UNITED STATES PATENT AND TRADEMARK OFFICE

APPLICATION NO.	FILING DATE	FIRST NAMED INVENTOR	ATTORNEY DOCKET NO.	CONFIRMATION NO.
10/538,776	04/17/2006	Tomonobu Hata	ASAIN0164	3713
24203	7590	03/31/2008	EXAMINER	
GRIFFIN & SZIPL, PC SUITE PH-1 2300 NINTH STREET, SOUTH ARLINGTON, VA 22204			HIGGINS, GERARD T	
			ART UNIT	PAPER NUMBER
			1794	
			MAIL DATE	DELIVERY MODE
			03/31/2008	PAPER

Office Action Summary	Application No. 10/538,776	Applicant(s) HATA ET AL.	
	Examiner GERARD T. HIGGINS	Art Unit 1794

DETAILED ACTION

Fig. 7A

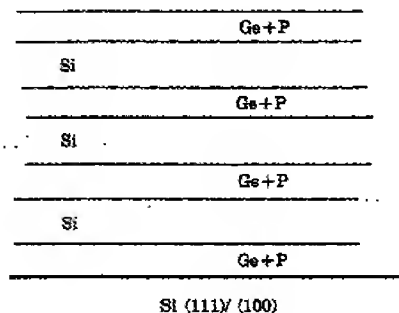
Sadatomi et al. disclose layered semiconductors on silicon wafer substrates that comprise thermoelectric conversion materials [0054] to [0061] and also Figures 7A and 8.

With regard to claim 13, the alternating layers of Si and Ge seen in Figures 7A and 8 of Sadatomi et al. comprise the singular or multiple elements of applicants' claim 13.

At [0060] Sadatomi et al. teach that the thermoelectric device may be comprised of p-n semiconductor type materials, they also teach the layered Si and Ge semiconductor structure in Figures 7A, 7B, and 8; further at [0067] and [0068] they teach that boron may be doped to provide holes (p-dope), and oxygen or nitrogen may be used to provide electrons (n-dope) in the semiconductor.

Fig. 7B

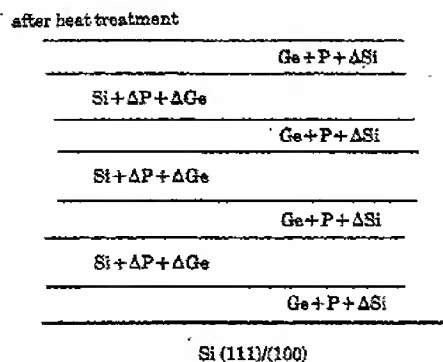
With regard to claim 15, the heat treatment conditions of Sadatomi et al. would form a device of Figure 7B.

In this device there is a physical property change because the layers are now a mixture of all of the individual layers.
